SEWAGE DISPOSAL SYSTEM

MARYLAND STATE DEPARTMENT OF HEALTH

SUBDIVISION Braeburn ROAD 10865 Braeburn Rd. LOT 13

ON-SITE SEWAGE DISPOSAL SYSTEM HOWARD COUNTY HEALTH DEPARTMENT BUREAU OF ENVIRONMENTAL HEALTH

P-26457

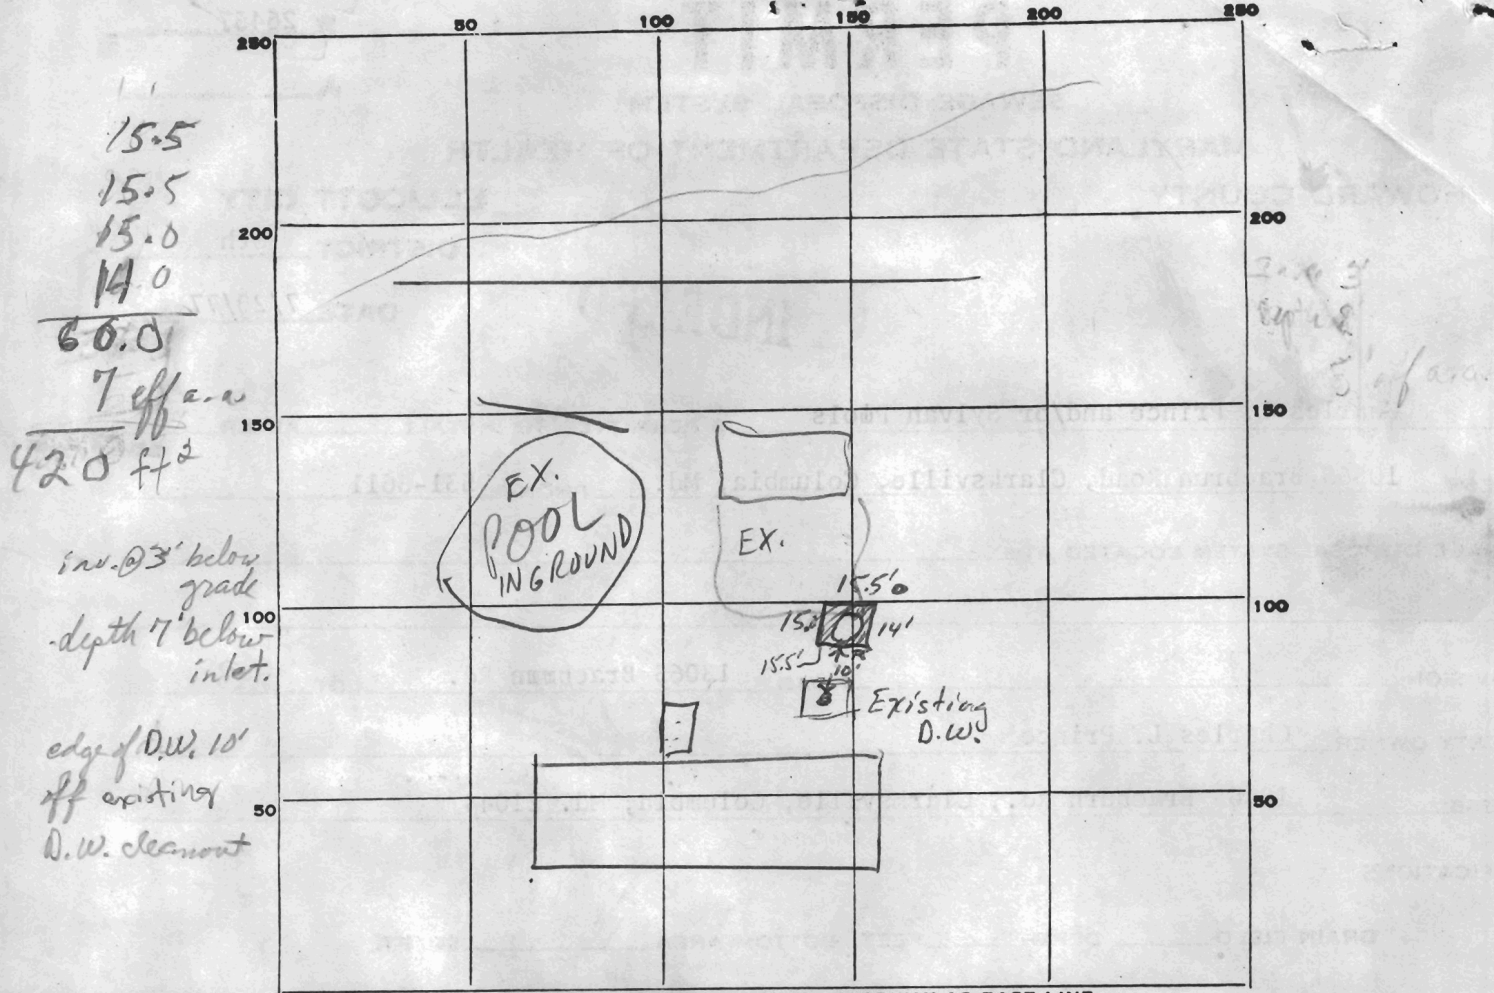
OK seepage pit 420' sidewall area inu 3' max 10' - put vertical 4" perforated pipe in center OK to back fill.

14' of trench
3' below grade
As to 2729 plastic

60' trench 14' 3'
max depth 10'

Old trapst pool 20' from edge of d/s
10' from edge of d/s

DATE SYSTEM APPROVED 8/9/77 INSPECTOR Thomas S. Ogb

516484

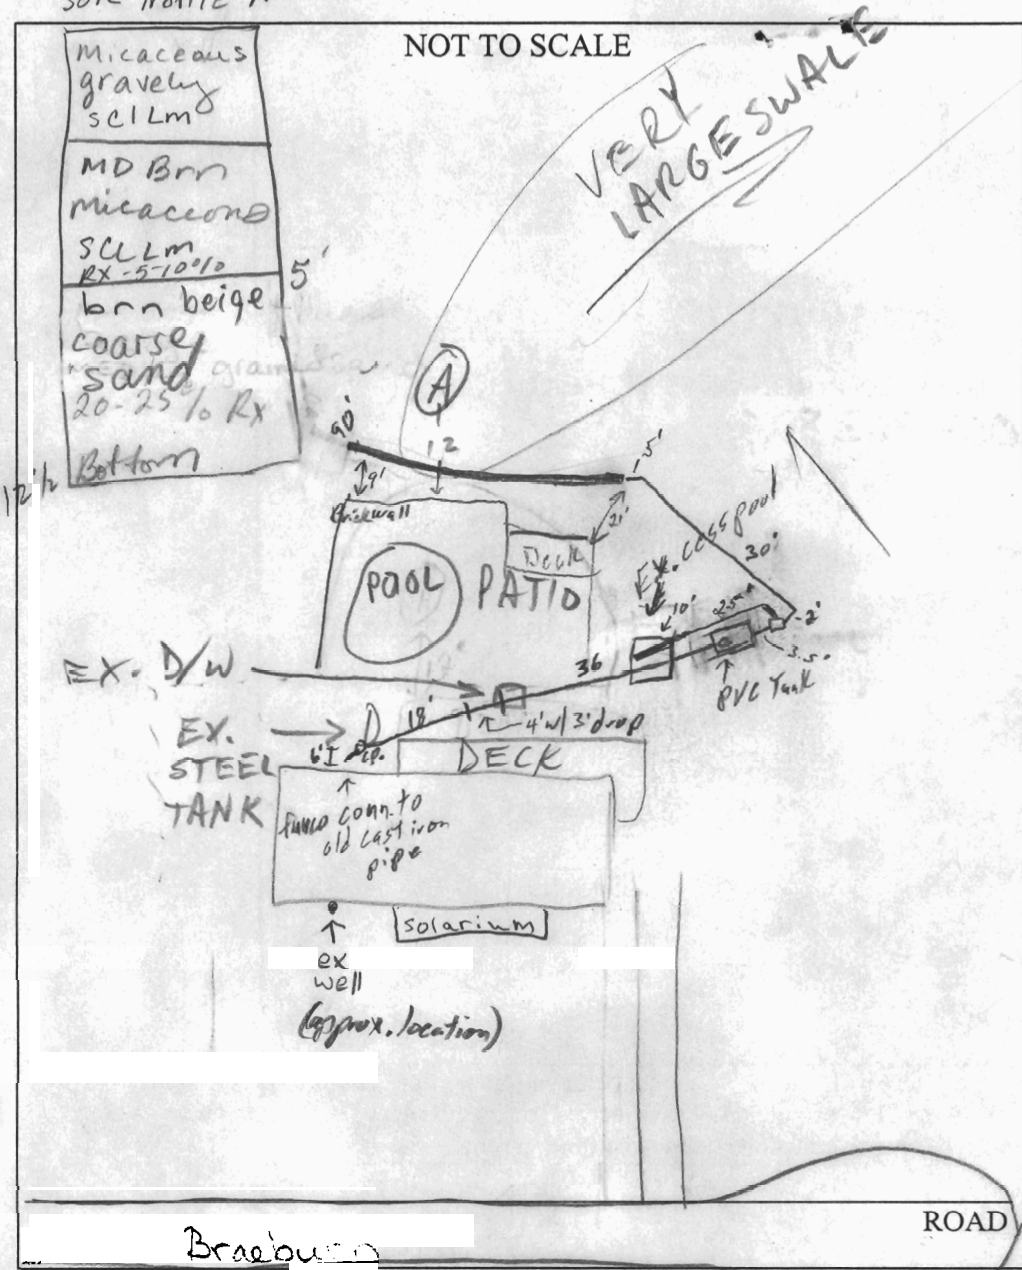
PRE-CONSTRUCTION 1/25/02 Replace S.T. with a fiberglass septic tank. Keep one dry well, and add 1-100' trench (MARKS)

INSTALLATION 2/11/02 Ex. D/W & Steel tank abandoned. Inlet to Ex. Coss pool ∴ 1' lower than previously. OK to cover all work (S)
